Application by Mallard Pass Solar Farm Limited for an Order Granting Development Consent for Mallard Pass Solar Project- EN010127

Submission by John Hughes: ID ref: 20036141

APP-057 Fields 18,19 & 26

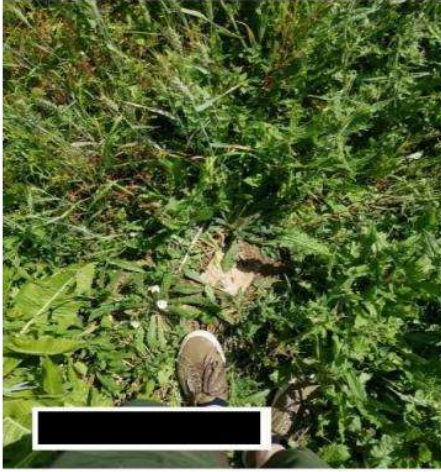
Following REP05-058 I'm asking if field 18 which is West of the East Coast Main Line and will be used during the construction stage of the proposed solar farm as a parking/construction area can have the PV arrays removed based on the following point.

- [REDACTED] has views across field 26, 18 & 19 internally from downstairs Kitchen, Lounge and Conservatory windows so PV arrays in field 18 will be visible internally 365 days a year.

- Other properties in [REDACTED] also have gardens backing onto field 26 with views over fields 18 & 19.
- The PV mounting structures will be what residents view so field 18 will have the appearance of a field of scaffolding and not glint and glare

- The proposed mitigated planting on the boundary between field 26 and 18 will not mitigate the view of the PV arrays mounting structures as the field elevates up and away from the planting line when looking south from the village, the field faces north.

- Residents west of the east coast mainline have seen no movement in PV arrays to further distance them from properties within the village along Stamford road while east of the ECML PV arrays have been moved back behind the gas pipeline with properties in lower parts of the village having the inclining topography helping mitigate the view.
